**North Little Rock Planning Commission**  
**March 11, 2025 - Agenda / Public Hearing 4:00 PM**  
**City Council Chambers – 300 Main Street, NLR, AR 72114**

**North Little Rock Planning Commission  
Minute Summary  
March 11, 2025**

**Item #3****SD2025-19 Giles Addition Lots 12 & 13 Blk 7 SPR @ 1217 W 7<sup>th</sup> Street**

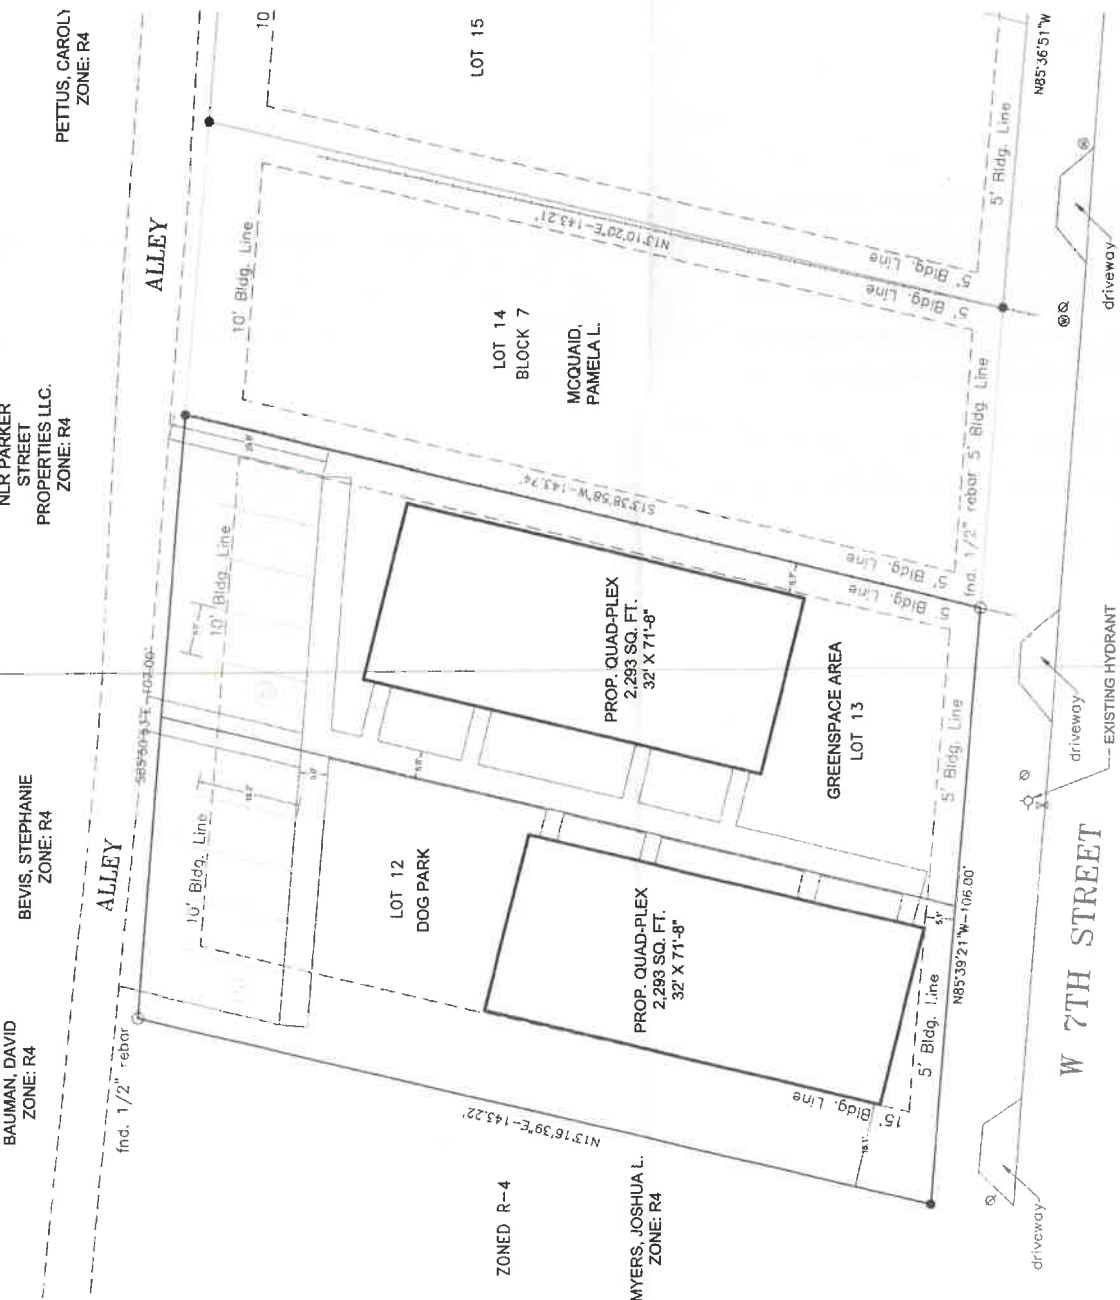
1. Engineering requirements on detention:
  - a. Option to pay the drainage in-lieu of fee of \$5000/acre instead of providing onsite detention.
2. Permit requirements/approvals submitted before a building permit will be issued:

- h. Driveway widths shall be labeled and shall be 10' minimum to 40' maximum.
  - i. All driveways are to be concrete within the ROW.
  - j. Provide ½ street improvements (street, drainage, curb and gutter, sidewalk, street lights) or a performance bond.

- a. Provide approved City Council ordinance on rezoning property to C6.
  5. Meet the requirements of Community Planning, including:
    - a. Provide the standard requirements of Zoning and Development Regulations.

- b. Provide dumpster location. Dumpster to have masonry screening.
    - c. No fence is to be within a front building line.
    - d. All exterior lighting shall be shielded and not encroach onto neighboring properties.

6. Meet the requirements of the Master Street Plan, including:
    - a. Provide 5' sidewalks and ramps with a minimum of 5' green space between sidewalks and curb to ADA standards and City standards.

- b. Provide ½ street improvements.
  7. Meet the requirements of the Screening and Landscaping ordinance, including:
    - a. All disturbed areas are to be sodded, fertilized, watered and mulched.

- b. Any new site development must comply with the City's minimal landscape and buffer ordinance requirements.
    - c. Provide a scaled landscape plan, graphically indicating plant material and locations, plant material legend noting the different plant materials, plant material list and specifications indicating minimum plant material size at installation.

- i. Provide note on landscape plan stating all turf and plant material shall be irrigated by an automatic underground irrigation system.
    - d. Provide street trees at a minimum rate 1 tree per 30 linear feet of property line adjacent to the street right-of-way.

- e. Provide a buffer/screening adjacent to the dissimilar land use to the east and south as defined by Section 7.2.4: Buffers between Dissimilar Uses.

- iv. An eight (8) foot tall, continuous opaque screen shall be provided. An opaque screen may include one (1) of the following: wall, fence, site grading, or plantings. No fence, wall and/or site grading is required with evergreen trees from Table E. The opaque screen must be opaque within 4 seasons.

- f. Trees shall be planted at the rate of one (1) tree per six (6) parking spaces.
    - i. Trees ten (10) feet from the edge of parking area may serve for the parking lot shading requirements, but may not satisfy more than fifty (50) percent of the overall requirement for the parking lot or area.

- g. A continuous screen of shrubs shall be required for any landscape strip adjacent to any parking area.
    - i. Only shrubs from the approved planting list will count toward this requirement, unless approved by the Planning Commission. Shrubs shall be eighteen (18) inches in height at planting and be planted a maximum three (3) feet apart.

- i. Landscape plans to be revised prior to the April 2025 Planning Commission Hearing.
8. Meet the following requirements concerning signage:
- a. All signs require a permit and separate review.
